Application for Five Variances, Each Subject to Three Conditions, Respecting One Third Party Electronic Ground Sign - 2200 Markham Road

Date: March 2, 2026

To: Sign Variance Committee

From: Project Director, Business Transformation, Toronto Building

Figure 3: Location of Proposed Sign in relation existing signs

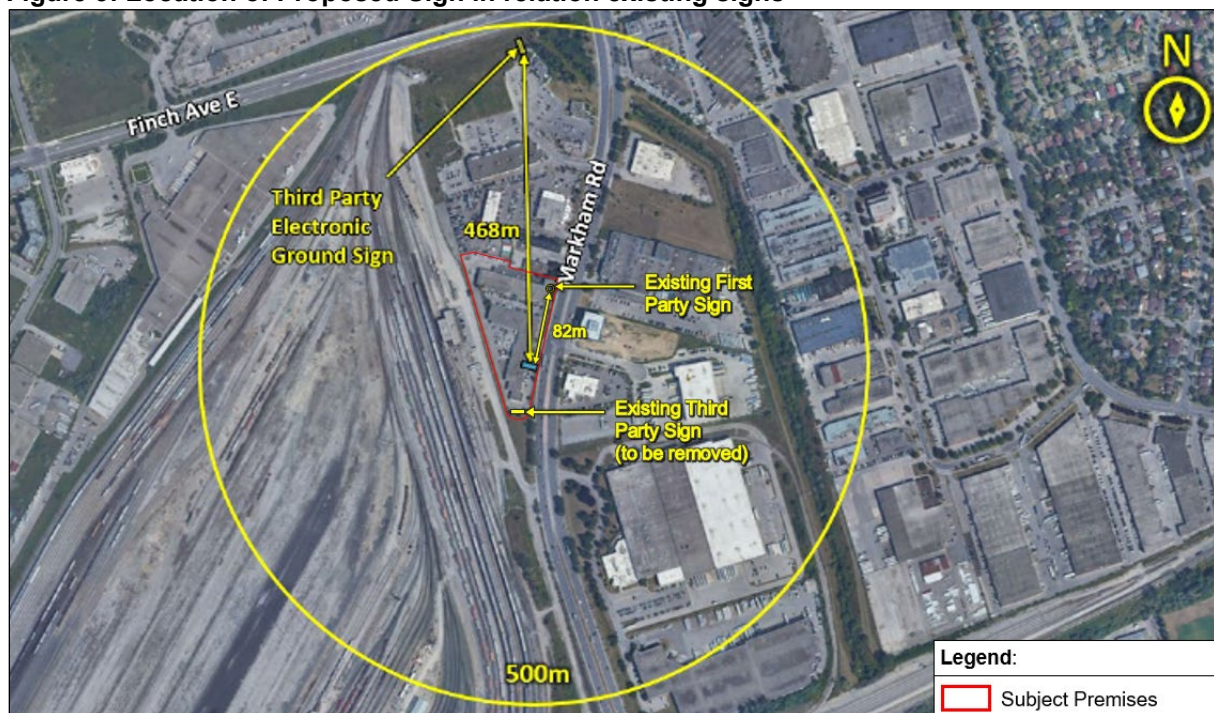
The Proposed Sign would be located approximately 468 metres from an existing third party electronic sign (the "Third Party Electronic Ground Sign") on an intersecting street, contrary to the 500-metre minimum separation required under Chapter 694. The Subject Premises also contains an existing first party ground sign (the "Existing First Party Sign"), triggering a variance to the provision permitting no more than one ground sign or electronic ground sign per premises.

A third party ground sign (the "Existing Third Party Sign") is currently located approximately 60 metres south of the Proposed Sign's location. This proximity would otherwise trigger a variance to the 150-metre separation requirement, however, the Applicant has proposed that approval of the Proposed Sign be conditional upon the removal of the Existing Third Party Sign (Attachment 2, p.11), thereby resolving the non-compliance.

A variance is required to permit the Proposed Sign to be located 468 metres from an existing third party electronic ground sign on an intersecting street, below the 500-metre minimum required under Chapter 694, and to allow an additional ground sign beyond what the By-law permits. These requirements are intended to prevent multiple sign faces from being visible simultaneously, thereby limiting visual clutter and potential driver distraction.

The Applicant notes that, despite the non-compliant distance, the separation between the the Proposed Sign and the Third Party Electronic Ground Sign remains substantial: the signs are on different streets, oriented in different directions, and screened by intervening buildings, preventing simultaneous visibility and maintaining the intent of the regulation (Attachment 2, pp. 13 and 20).

- Condition 1: Prior to the issuance of any permit for the Proposed Sign, the existing third party ground sign located on the Subject Premises shall be removed, and all associated permits revoked.
- Condition 2: The interior angle of the sign faces shall not exceed 45 degrees.
- Condition 3: The illumination system for the Proposed Sign shall operate at a correlated colour temperature (CCT) of 3000 K or lower.

Figure 4: Land Use Map of Subject Premises and Surrounding Area

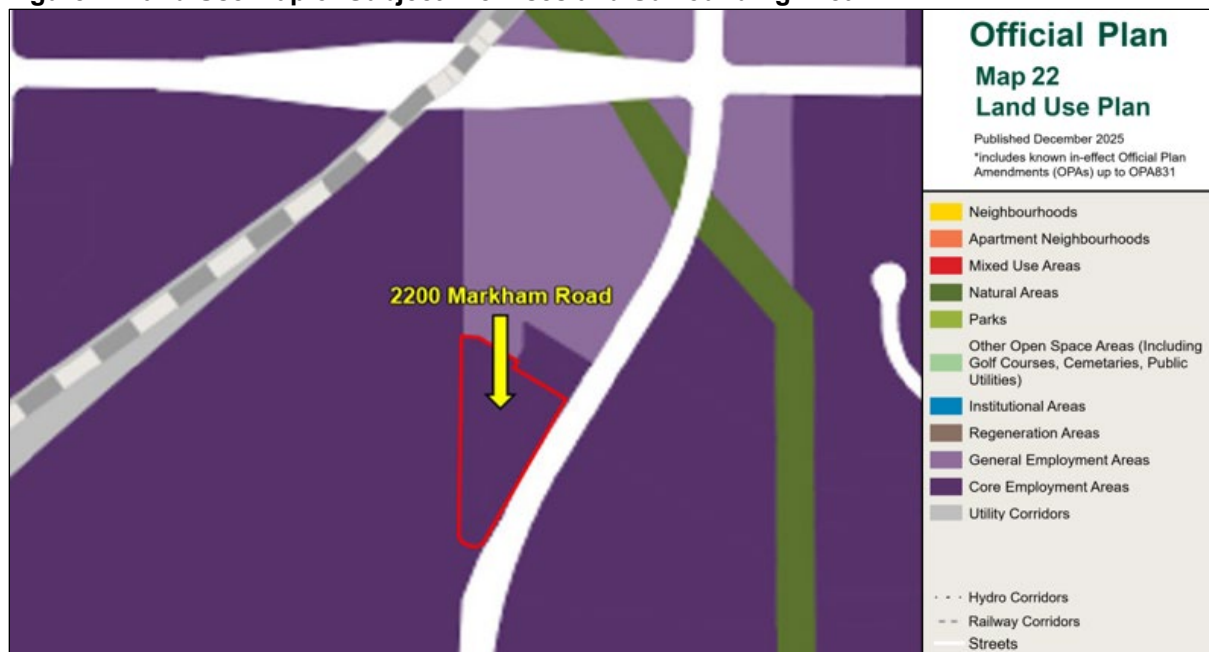
The Applicant notes that the Subject Premises is designated Core Employment Area, with surrounding lands designated Core Employment and General Employment (Attachment 2, p. 18).

They submit that Core Employment Areas are intended for business and economic activity and, although no specific numbered Official Plan policies are cited, the submissions describe general alignment between the Proposed Sign and Employment Area objectives of supporting business exposure, enhancing visibility, and complementing the economic activity associated with the designated land use (Attachment 2, p. 18).

Based on the Applicant's submissions, the Proposed Sign appears to align with the economic-activity functions of Employment Areas without conflicting with planned land-use direction. As such, the CBO is satisfied that this criterion has been established.
